ADDENDUM

No. 02 Date: 9/5/2024
Project No. 0020711.01 Attention: Leonard D'Souza
Project Name: Princess Margaret Cancer Centre
Stem Cell Transplant 2, MHC, MHDU, DSC
Address: University Health Network
610 University Avenue
Toronto ON

Project Name:	UHN PM Stem Cell Transplant Phase II Part A	Date Issued:	September 5, 2024
Quasar Project #:	HC-21-058		
Distribution			
Cannon Design Ltd.	Linda Vela	lvela@cannondesign.com	
Cannon Design Ltd.	Jennifer Huynh	jhuynh@cannondesign.com	
Quasar Consulting Group	Alexandra Blagojevic	alexandra.blagojevic@quasarcg.com	
Quasar Consulting Group	Jerry Guidarelli	jerry.guidarelli@quasarcg.com	
Quasar Consulting Group	Jomuel Estranero	jomuel.estraneo@quasarcg.com	
Quasar Consulting Group	Manda Bobinac	manda.bobinac@quasarcg.com	
Addendum #:	M-1		
Revision #:	0

Project Name:	UHN PM Stem Cell Transplant Phase II Part B	Date Issued:	September 5, 2024
Quasar Project #:	HC-21-058		
Distribution			
Cannon Design Ltd.	Linda Vela	lvela@cannondesign.com	
Cannon Design Ltd.	Jennifer Huynh	jhuynh@cannondesign.com	
Quasar Consulting Group	Alexandra Blagojevic	alexandra.blagojevic@quasarcg.com	
Quasar Consulting Group	Jerry Guidarelli	jerry.guidarelli@quasarcg

1 ELECTRICAL - 1ST FLOOR DEMOLITION & NEW WORK PLAN
SCALE 1: 200

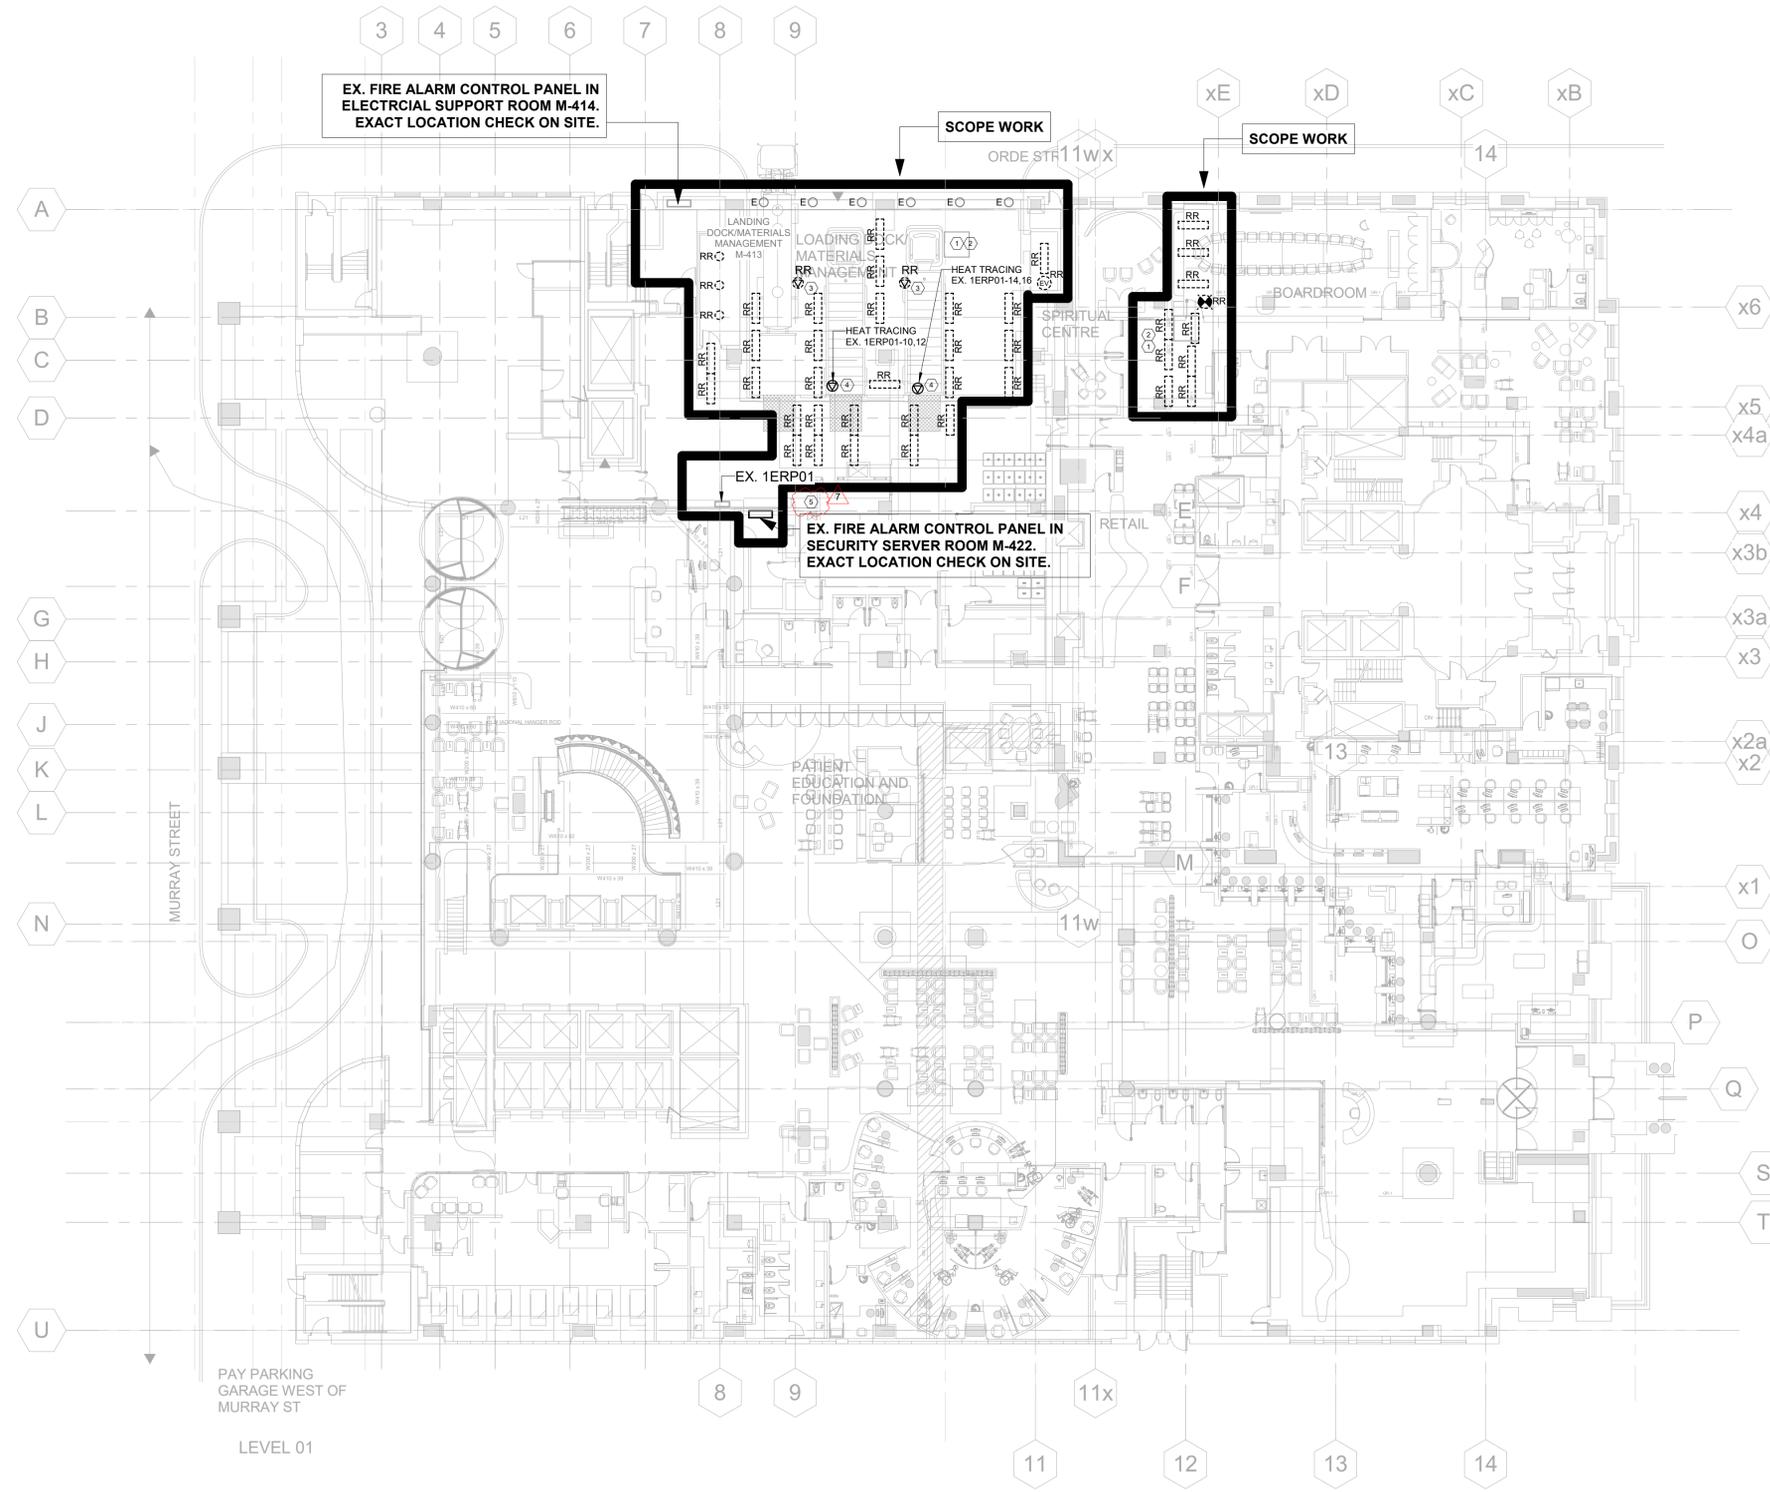
QCG E: (71) Fire alarm panel shown on E0101, E0103 AND E0108 are existing fire alarm panels. The scope work only includes updating these fire alarm panels to suit new fire alarm circuits. Note added to clarify this scope of work on E0101, E0103, E0108 as part of Addendum E1.

- 5 UPDATE EXISTING FIRE ALARM PANEL TO SUIT NEW FIRE ALARM CIRCUITS PROVIDED. PROVIDE NEW SUB FIRE ALARM PANEL IF EXISTING PANEL SPACES ARE NOT ENOUGH.

**POWER & SYSTEMS-
DEMO WORK LVL5A
MHDU**

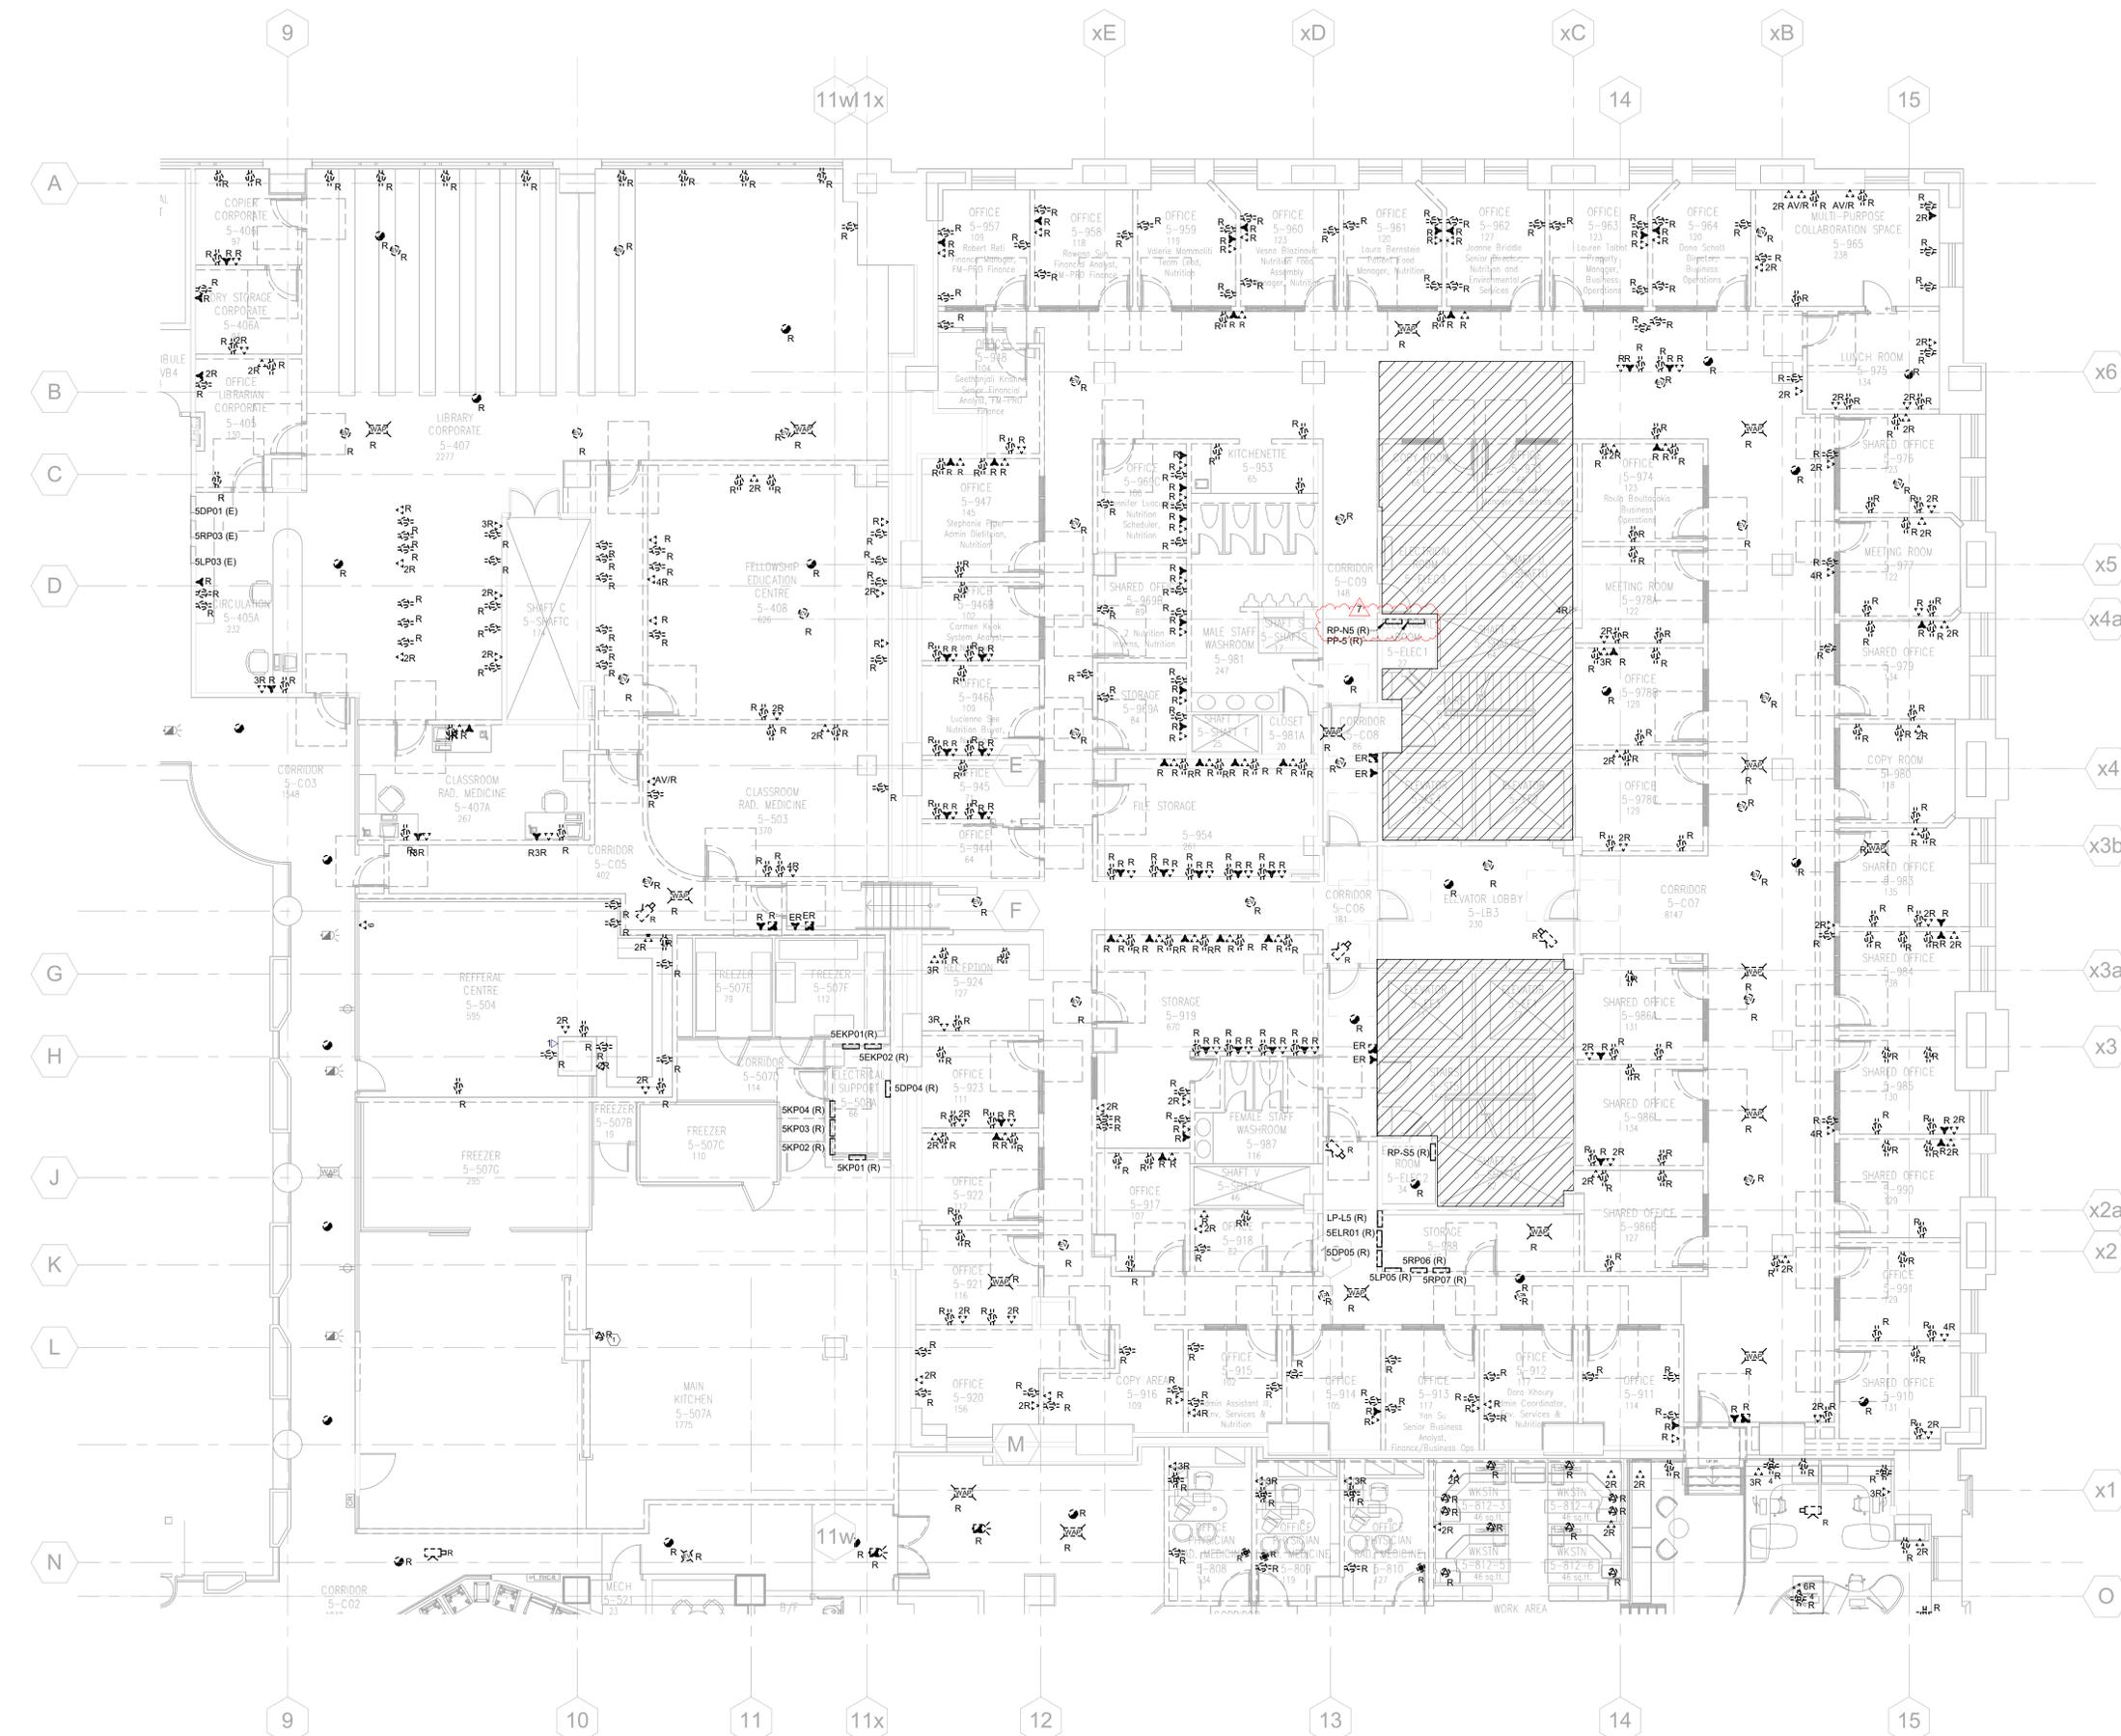
4. **Drawing E-1105A – POWER & SYSTEMS-DEMO WORK LVL5A MHDU**
- Modification Clouded in Compliance with RFI question (47)
5. **Drawing E-2205A– LIGHTING - NEW WORK LVL 5A – MHDU**
